A d d e n d u m

Iowa Department of Transportation
Office of Contracts

B.O.	Proposal ID	Proposal Work Type	County	Project Number	Addendum
306	78-0293-102	GRADING	POTTAWATTAMIE	IM-NHS-029-3(102)48--03-78 IM-NHS-029-3(103)48--03-78 IM-NHS-029-3(104)48--03-78 IM-029-3(105)48--13-78 NHS-029-3(106)48--11-78 IM-NHS-029-3(110)48--03-78 IM-NHS-029-3(122)48--03-78 IM-NHS-029-3(146)48--03-78 IM-NHS-080-1(416)3--03-78	17FEB306.A10

Make the following changes to IM-NHS-080-1(416)3--03-78 plans.

PROJECT NUMBER: IM-NIS-080-161635-03-78
 POTTAWATTAMIE COUNTY
 SHEET NUMBER: 38A

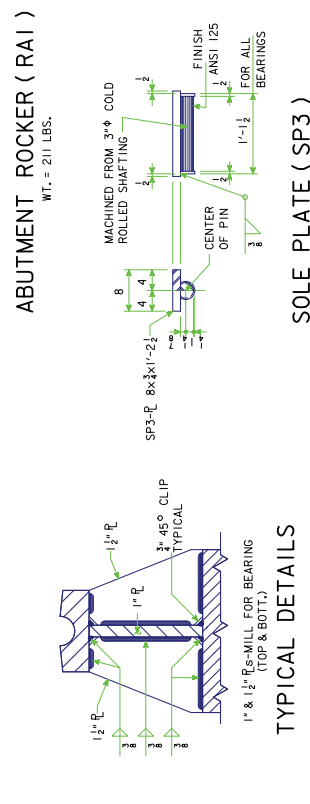
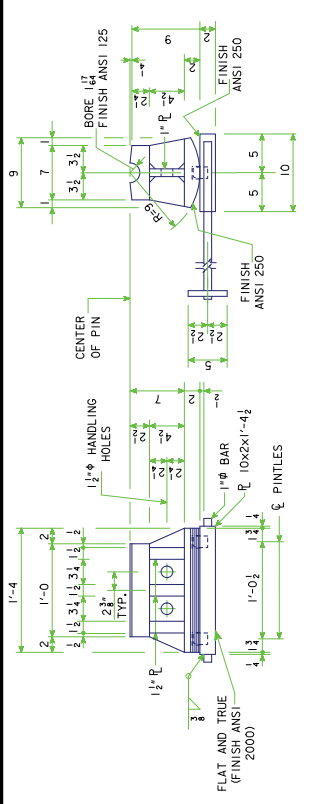
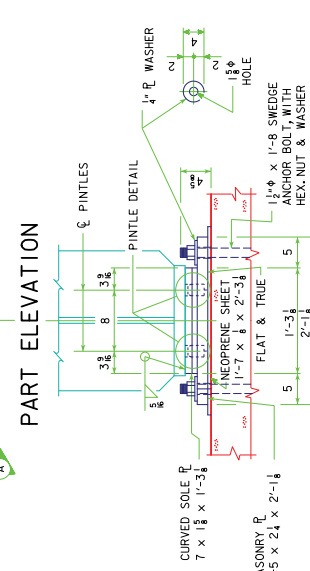
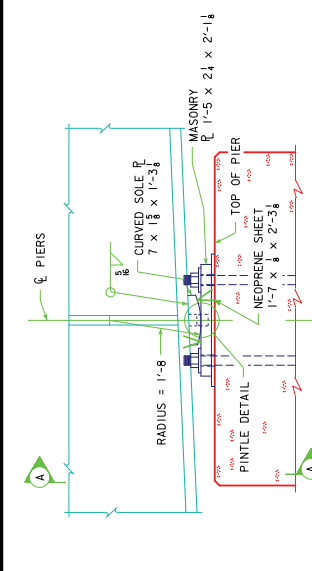
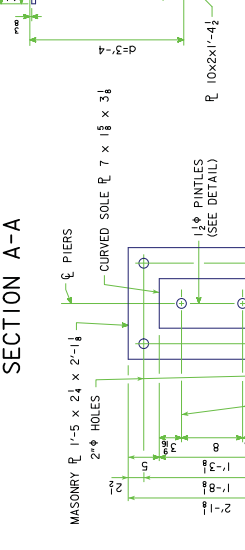
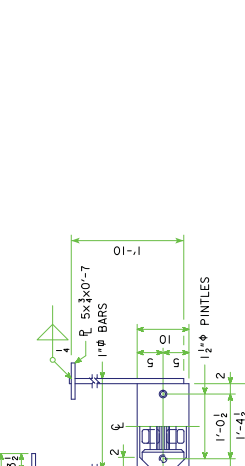
Add attached alternate sheet 38A.

This sheet provides a Rocker Weldment Alternate to the Cast Iron Rocker detailed on Sheet 38. The Contractor can use Rocker Weldment Alternate with no additional payment for the added Structural Steel weight.
